# TNRIS Central Texas Final QA Report

LIDAR QA/QC FOR CENTRAL TEXAS  
STATEMENT OF WORK #580170806

TEXAS WATER DEVELOPMENT BOARD

Draft Report Submitted December 14, 2017  
Final Report Submitted January 5, 2018

Figure 5 – Reflight required to mitigate narrow swath overlap

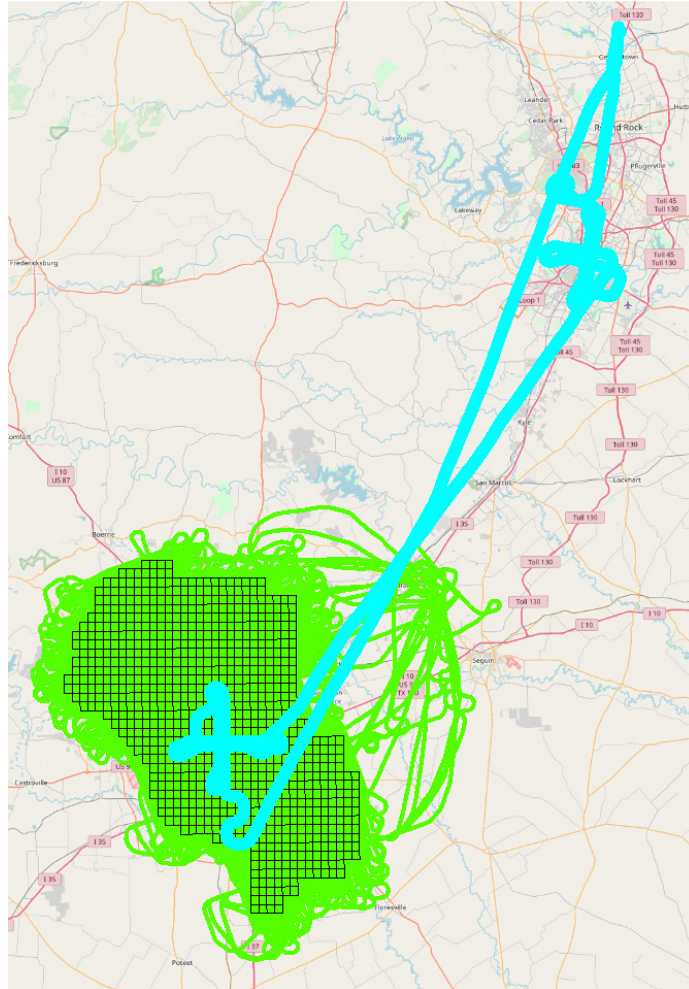
Note: As part of Fugro's internal checks a concern was discovered where the level of swath overlap may be too low. As result Fugro flew additional swaths over the section of San Antonio where there were taller structures in an effort of ensure no LiDAR shadows persisted in the final data. Graphics of the additional sortie is presented below in cyan.

Figure 6 - Fugro LiDAR Planned Control Locations (X) and Actual Control Locations (▲)

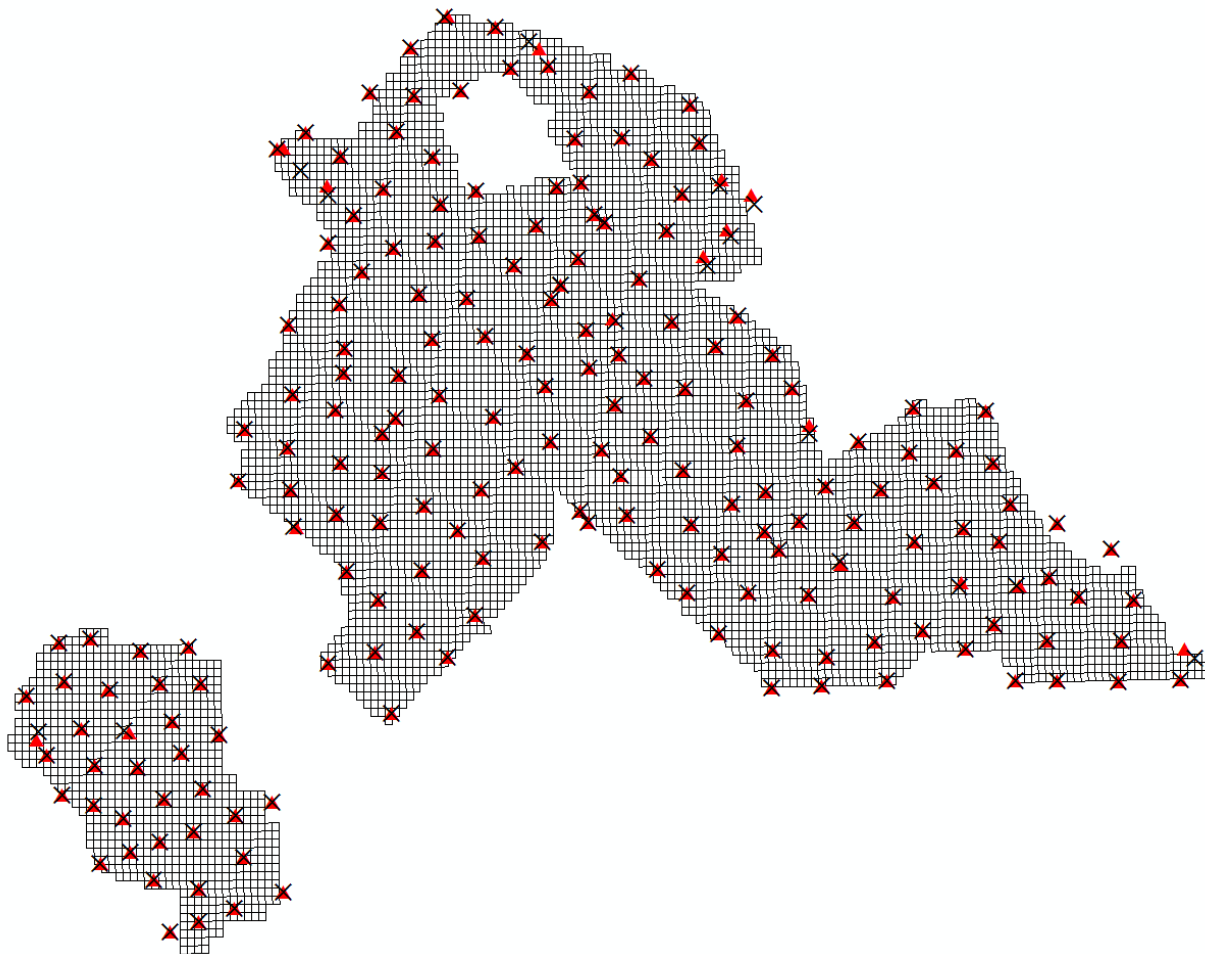
It was noted the baseline distances of the control points exceeded 40 km in some instances. AECOM queried Fugro how frequently Fugro utilized control points with similar baselines. Fugro indicated that utilizing control derived from similar baselines was part of their common procedures and Fugro has not encountered accuracy issues in the past. Fugro sent inquires to Gorrondona if there were any concerns regarding the baseline lengths reported and the control meeting the accuracy of the data. Gorrondona indicated confidence in the accuracy of the data meeting project requirements. The reported estimated accuracy of the adjusted coordinates is  $\pm 0.005\text{m}$  at CE95.

Survey points were evenly spaced, well dispersed, and closely mimics the planned control point locations, as can be seen in the graphics below.
